Re: Comments on 200/400G- ER4/8 Link Budgets (#38,#39)

IEEE P802.3cn Meeting, ad hoc call, May 9th, 2019

Comments #38, #39 on D2.0 for 200G/400G ER4/8

Table 122-13—200GBASE-FR4, 200GBASE-LR4, 200GBASE-ER4, 400GBASE-FR8, and 400GBASE-LR8, and 400GBASE-ER8 illustrative link power budgets

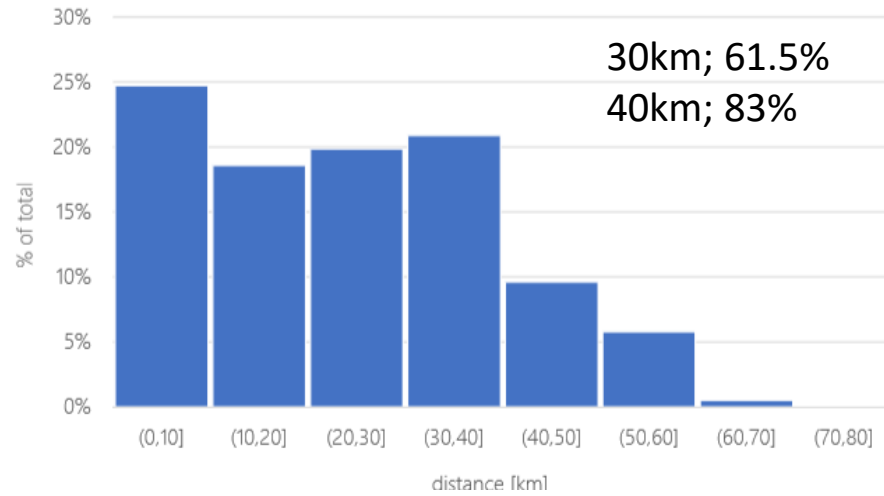
- Current 400G illustrative budgets in Table 122-13 for 30 and 40km follows exactly same 100G format, so may expect similar difficulty in fields.

Question: if we like the standard to be written in more meaningful and compelling manner, how should we handle this situation?

Microsoft DCI fiber plant distance and loss distributions as of 03/2018

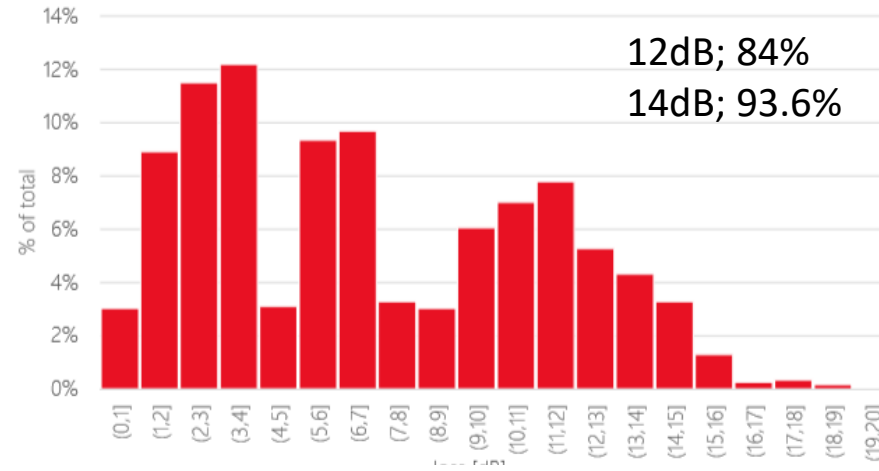
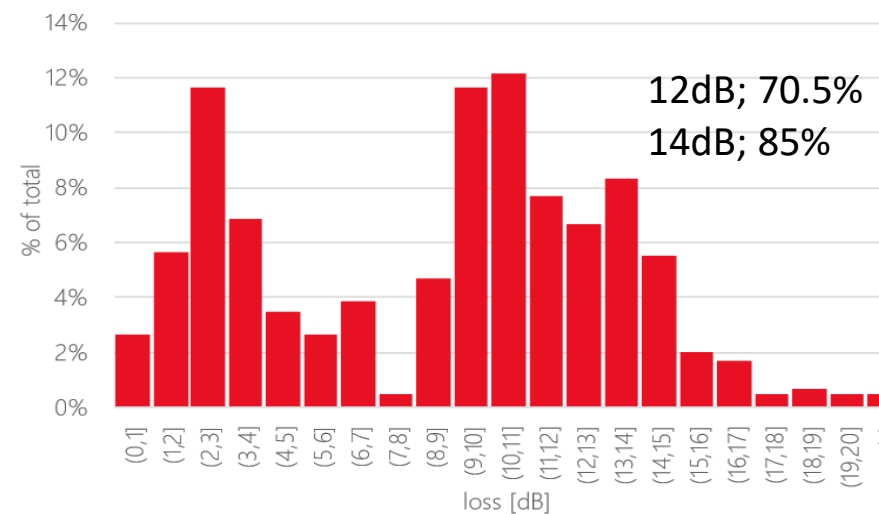
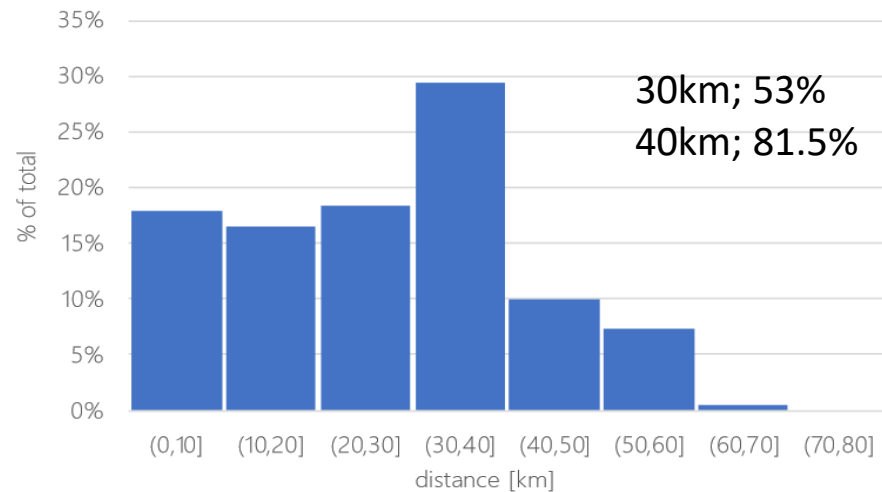
30/40km Fiber distributions (1)
